HISTORIC AND DESIGN REVIEW COMMISSION

October 18, 2017

HDRC CASE NO: 2017-530
ADDRESS: 925 BURNET ST
LEGAL DESCRIPTION: NCB 01656 BLK D LOT W 25 FT OF N 60 FT & S 131 FT OF 16
ZONING: R-5, H
CITY COUNCIL DIST.: 2
DISTRICT: Dignowity Hill Historic District
APPLICANT: Cyrus Askin
OWNER: Cyrus Askin
TYPE OF WORK: Wood and aluminum window replacement
REQUEST:

Window Plan (*not to scale*)

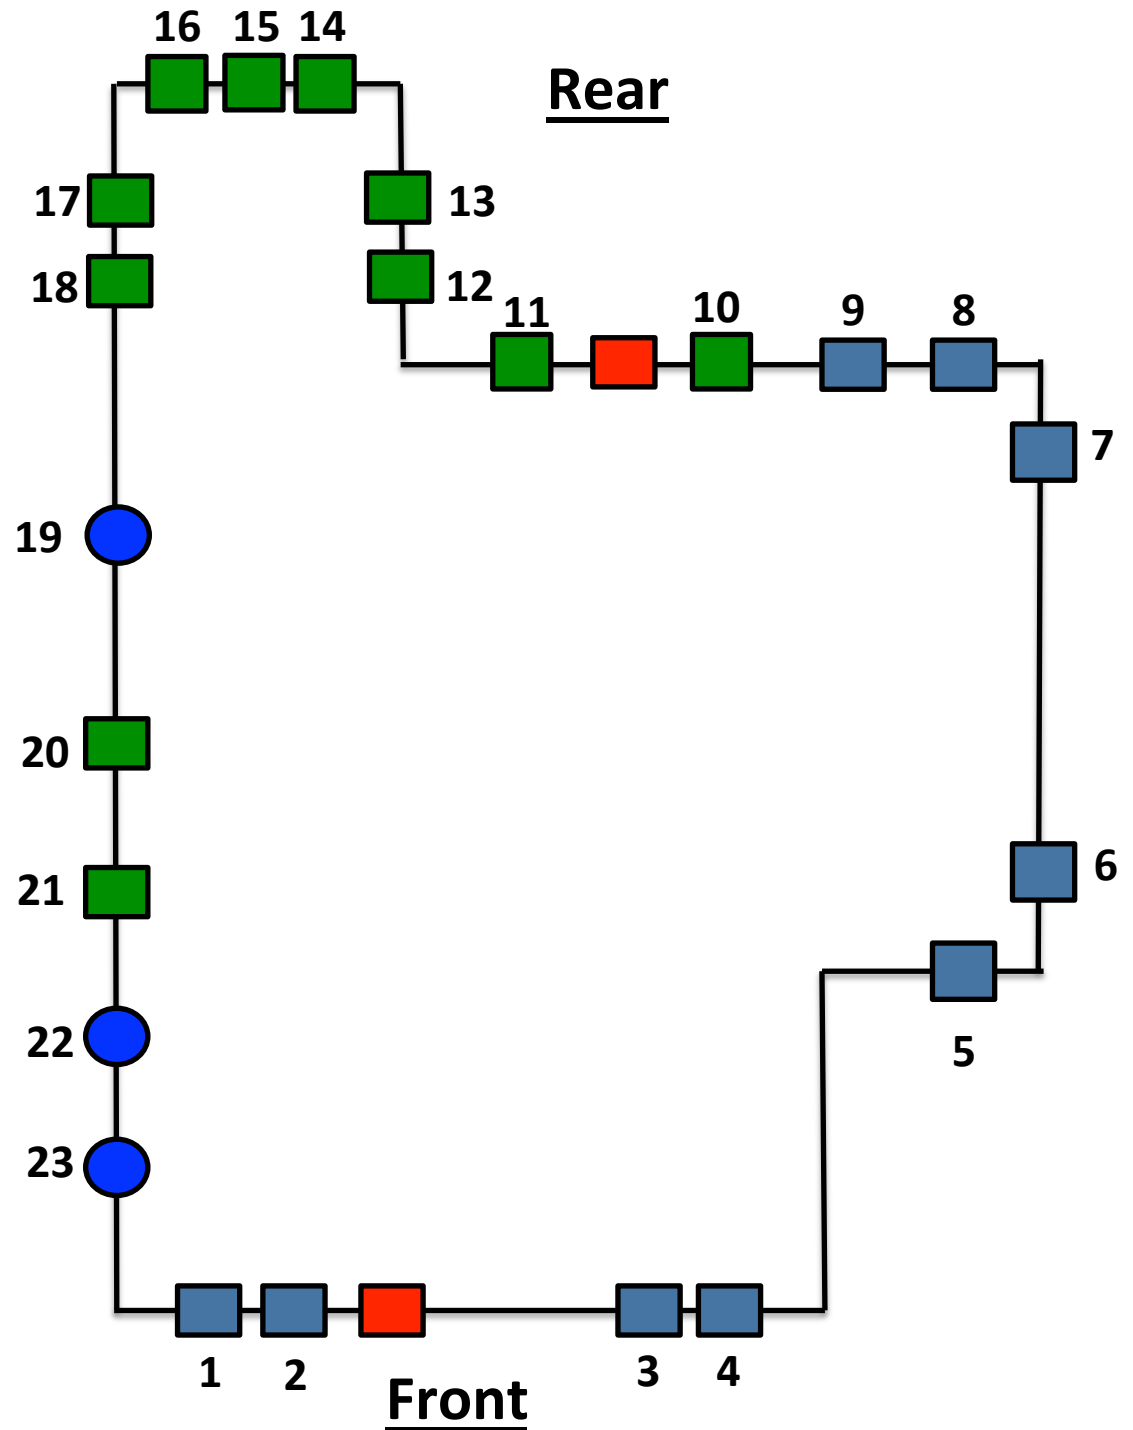
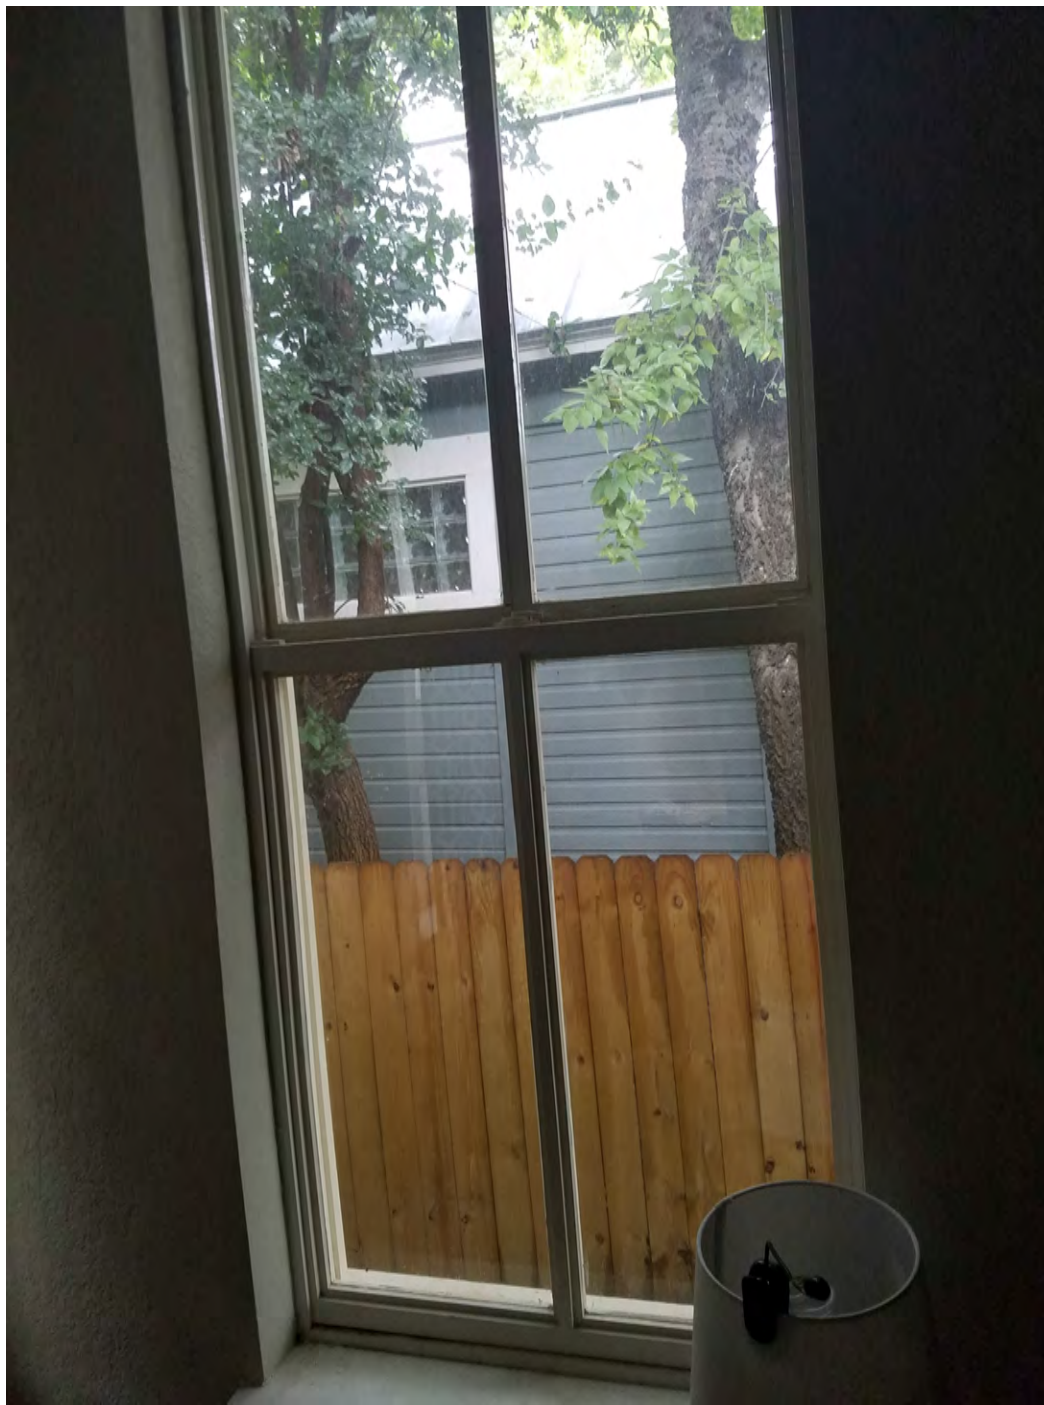
Staff does not find the installed replacement windows to be a compatible replacement for the original wood windows. If the commission approves the windows as installed, then staff recommends that wood windows screens be installed as mitigation to maintain a more traditional appearance from the street.

Staff recommends approval of item #2. Staff finds that these windows have been installed in a manner that is consistent with the previous approval.

Staff recommends approval of item #3, the installation of three fixed vinyl windows where previous windows were removed.

Staff does not recommend approval of item #4, the removal of the transom window above the front door. Staff finds that this should be reinstalled.
